**SOUTH ESSEX PARKING PARTNERSHIP  
(TRAFFIC REGULATION ORDERS) SUB COMMITTEE**

<b>Subject</b>	<b>THE ESSEX COUNTY COUNCIL (CHELMSFORD CITY) (PROHIBITION OF WAITING, LOADING AND STOPPING) AND (ON-STREET PARKING PLACES) (CIVIL ENFORCEMENT AREA) (AMENDMENT NO.56) ORDER 202*</b>  Relating to Mill Lane, Broomfield
<b>Report by</b>	South Essex Parking Partnership Manager

## APPENDIX 2

### REPRESENTATIONS & RESPONSES FOLLOWING FORMAL ADVERTISEMENT 05 OCTOBER 2023 – 27 OCTOBER 2023

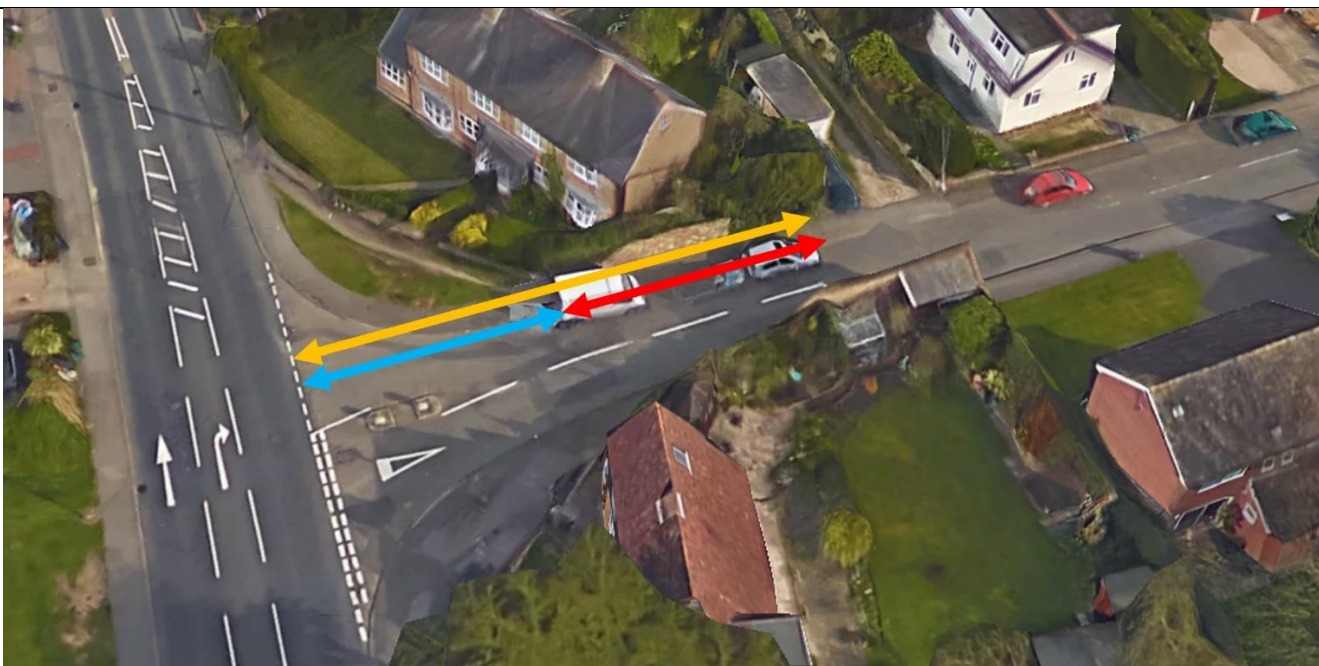
Representations & Responses relating to Mill Lane, Broomfield		
Ref	Representation	Technician Response
1	<p><b>Email 1:</b> Good Afternoon,</p> <p>I am writing to formally notify my objection to the 20 metre “No Waiting at Any Time” proposed for Mill Lane Broomfield as indicated on the notice reference ‘TL705 102 Rev 0 to Rev1, TL705 100 Rev 1 to Rev 2’</p> <p>There are a number of nearby properties that rely solely on the on street parking, the proposal for 20 metres of no waiting zone is unnecessary, will make the road more dangerous and will waste existing parking space for 2 vehicles that is much needed by local residents.</p> <p>Rule 243 of the highway code states:</p> <p><i>“DO NOT stop or park:</i></p> <ul style="list-style-type: none"> <li><i>• Opposite or within 10 metres (32 feet of a junction except in unauthorised parking space”</i></li> </ul> <p>Therefore the proposed 20 metre no waiting zone is double the distance required by the highway code which is underpinned by significant research into the matter. I agree that a 10 meter no waiting zone is sufficient as nobody should be parked within 10 metres from a junction as indicated in the highway code however I can’t see why 20 metres would create any benefit other than to stop public cars parking outside the adjoining property which obviously isn’t a suitable reason to remove on street parking which has been in place since the roads construction decades ago prior to the construction of adjoining properties. Please see illustration below to clarify the point:</p>	<p>Objection noted.</p> <p>Vehicles that park on and near to the junction of Mill Lane and Main Road create problematic and unsafe movement of vehicles and pedestrians as well as access and egress problems. Although there have been no recorded collisions at this location within the last 3 years, there have been fatal collisions at other nearby junctions off Main Road within the past 3 years. The introduction of these restrictions seek to remove dangerously parked vehicles whilst allowing ample off-street parking in safe locations.</p> <p>The SEPP cannot comment on matters pertaining to planning, or the such like, as it is outside their remit. However, it should be noted that the highway is intended for the purposes of passing and re-passing and that no right of parking exists.</p>

Orange Line = Proposed no waiting zone  
 Blue Line = Area that highway code does not permit parking in  
 Red Line = Existing parking that is proposed to be removed unnecessarily

The 20 metre no waiting zone proposal has the following detrimental effects unnecessarily:

- Reduces the capacity for net dwelling density as detailed in PPS3 (Planning Policy Statement 3)
- Contravenes section 51 of PPS3 as it doesn't account for expected or current levels of car ownership
- Contravenes table 5.1 Residential Car Parking Standards (standard spaces per dwelling) of the Chelmsford council April 2022 Parking Strategy and Standards Duty
- Reduces the local parking capacity so that local properties no longer have the amount of parking spaces shown in table 1 section 2 of the Chelmsford City Council Interim Residential Parking Guidance February 2015

Parking provision is therefore a concession and, however desirable, should not be at the expense of the purpose of the highway. Where it is safe and desirable parking can be allowed. Mill Lane does allow for ample on-street parking in safe locations.

It should be noted that the drawings shown on the aerial image are incorrect and is not what has been proposed under Chelmsford Amd 56. The proposed restrictions extend to approx. the front of the white van as shown in the aerial image.

The wide bell-mouth which leads to a narrow road and the location of a pedestrian crossing on the junction dictate that the usual 10m of junction protection are required to be extended. Vehicles parked within 20m of the junction are not considered to be parked in a safe location. These vehicles reduce visibility and cause conflict for vehicles travelling in opposite directions. It is unlikely that these proposed restrictions will increase traffic speeds. The proposed restrictions will improve

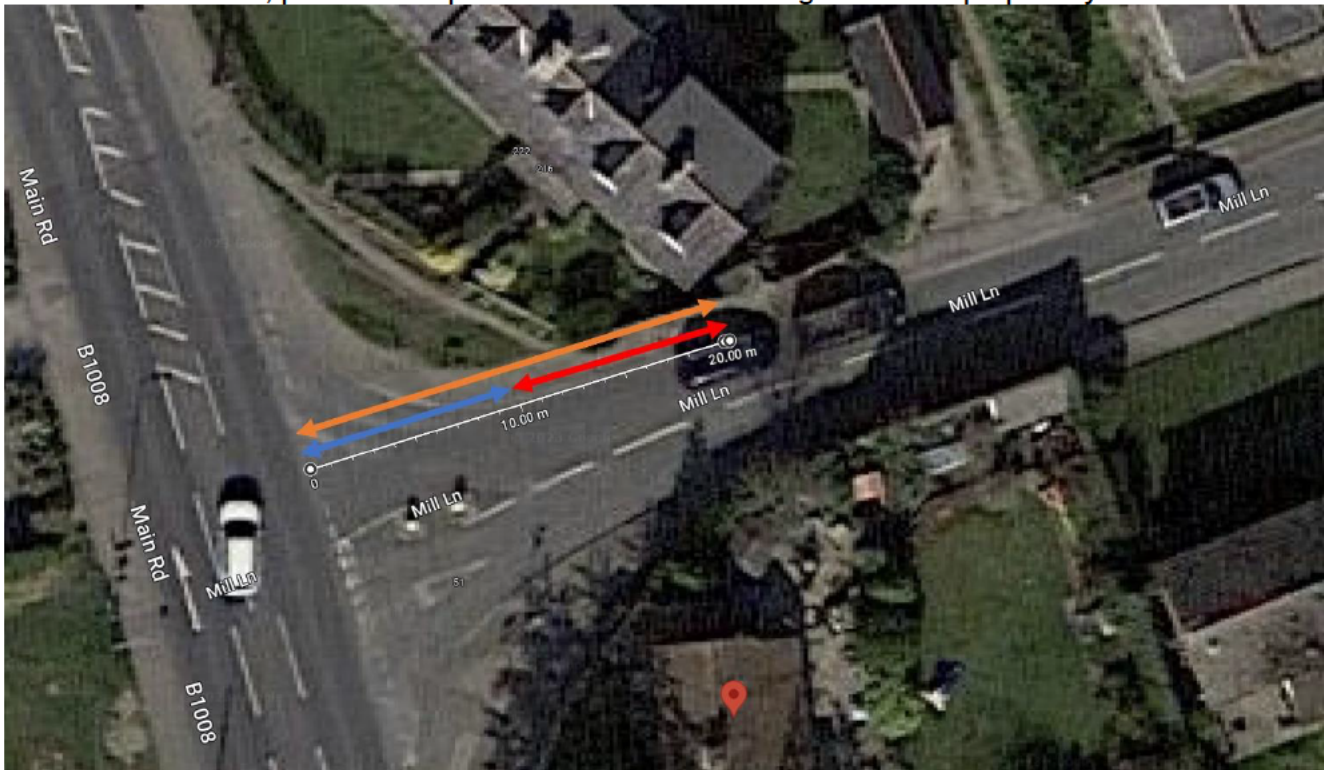
Further to the below, please see updated schematic which aligns with the proposal you clarified:

Orange Line = Proposed no waiting zone

Blue Line = Area that highway code does not permit parking in

Red Line = Existing parking that is proposed to be removed unnecessarily

<p>As you can see in the screenshot, there is a car that is parked without issue/obstruction that would be parked illegally under the new scheme unnecessarily. By removing a superfluous 3-4 metres from your proposal the amount of parking spaces available would double without any impact on the surrounding area and the "No waiting" zone would still be 60-70% greater than required by the highway code.</p> <p>Please do consider my proposal as a lot of unnecessary meetings and consultation could be avoided quite easily.</p> <p>Kind Regards,</p> <p></p>	
2	<p>To whom it may concern,</p> <p>I am writing in objection to the above notice reference 'TL705 102 Rev 0 to Rev1, TL705 100 Rev 1 to Rev 2' which details the proposal to extend the no parking/waiting zone in Mill Lane Broomfield, from the required 10m to an unnecessary 20m.</p> <p>As a grandparent who regularly visits family living nearby, the loss of more parking spaces would be detrimental to myself and other visitors/trades such as delivery vehicles/dust carts etc as well as those living in the road, who need the parking spaces for their homes. With the statutory rules already in place, forbidding parking within 10m of a junction (Rule 243 of the Highway Code), I see no reason to introduce further restrictions which will make life more difficult for those needing the parking spaces. The 10m rule ensures the safety of those using the road adequately. The enforcement of parking restrictions at the top of the road will surely only move traffic further down Mill Lane, causing problems for residents there, or worse still onto Broomfield Road, which is already very busy and needs to be kept clear for ambulances/emergency vehicles for the hospital.</p> <p>Parking is already very restricted in this area, especially with parents needing to use the road for parking for the nearby school. The parking of vehicles after 10m acts as a visual speed reduction barrier. I worry that should cars not be able to park in the proposed area, vehicle speed will increase when joining from Broomfield Road, giving rise to increased accidents involving pedestrians, especially parents with children.</p>	<p>Objection noted.</p> <p>Vehicles that park on and near to the junction of Mill Lane and Main Road create problematic and unsafe movement of vehicles and pedestrians as well as access and egress problems. Although there have been no recorded collisions at this location within the last 3 years, there have been fatal collisions at other nearby junctions off Main Road within the past 3 years. The introduction of these restrictions seek to remove dangerously parked vehicles whilst allowing ample off-street parking in safe locations.</p> <p>It should be noted that the highway is intended for the purposes of passing and re-</p>

<p>I have lived in Chelmsford all my life (and in Broomfield itself for 25 years) and have never known the junction of Broomfield Road with Mill Lane to be a problematic traffic area, please do not allow it to become one now.</p> <p>Kind regards</p> <p>██████████</p>	<p>passing and that no right of parking exists. Parking provision is therefore a concession and, however desirable, should not be at the expense of the purpose of the highway. Where it is safe and desirable parking can be allowed. Mill Lane does allow for ample on-street parking in safe locations. However, it thought that no more than one vehicle will be displaced which is likely to be a resident's vehicle. It is unlikely residents and/or their visitors will park their cars on Main Road.</p> <p>The wide bell-mouth which leads to a narrow road and the location of a pedestrian crossing on the junction dictate that the usual 10m of junction protection are required to be extended. Vehicles parked within 20m of the junction are not considered to be parked in a safe location. These vehicles reduce visibility and cause conflict for vehicles travelling in opposite directions. It is unlikely that these proposed restrictions will increase traffic speeds. The proposed restrictions will improve sightlines for all road users and pedestrians, better facilitate the passage of traffic, prevent</p>

conflict between vehicles and enforce Rule 243 of the Highway Code. The SEPP reserves the right to implement a scheme to improve safety and sight lines.
3	<p>To whom it may concern,</p> <p>I am writing to formally object to the 20 metre 'No Waiting at Any Time' zone proposed for Mill Lane, Broomfield as indicated on the notice reference 'TL705 102 Rev 0 to Rev1, TL705 100 Rev 1 to Rev 2'.</p> <p>Rule 243 of the highway code states <i>"DO NOT stop or park opposite or within 10 metres (32 feet) of a junction except in an authorised parking space"</i>. This seems an acceptable and perfectly adequate distance to me.</p> <p>I therefore consider any 'No waiting at any time' zone greater than 10 metres from a junction excessive. Furthermore, in this particular instance, the increase to 20 meters would result in the unnecessary removal of 10 metres of on-street parking which has the potential to result in the following:</p> <ul style="list-style-type: none"> <li>-Reduced public amenity for nearby properties that rely on the on-street parking</li> <li>-Relocation of parked vehicles further down Mill Lane which already suffers with inadequate on-street parking</li> <li>-Relocation of parked vehicles onto Main Road which is a busy route for traffic, buses and emergency services to the hospital</li> <li>-Increased speed of vehicles joining Mill Lane from Main Road due to the lack of parked vehicles acting as a visual and physical speed reduction cue (which would in turn increase the risk to pedestrians crossing Mill Lane which is a popular route to the nearby schools)</li> </ul> <p>I regularly drive on Mill Lane and cannot see any reason for the "No Waiting at Any Time" zone to be greater than 10 metres therefore I oppose the proposed 20 metre zone.</p> <p>Thank you for your consideration and please do not hesitate to contact me should you require more information.</p>	<p>Objection noted.</p> <p>Vehicles that park on and near to the junction of Mill Lane and Main Road create problematic and unsafe movement of vehicles and pedestrians as well as access and egress problems. Although there have been no recorded collisions at this location within the last 3 years, there have been fatal collisions at other nearby junctions off Main Road within the past 3 years. The introduction of these restrictions seek to remove dangerously parked vehicles whilst allowing ample off-street parking in safe locations.</p> <p>It should be noted that the highway is intended for the purposes of passing and re-passing and that no right of parking exists. Parking provision is therefore a concession and, however desirable, should not be at the expense of the purpose of the highway. Where it is safe and desirable parking</p>
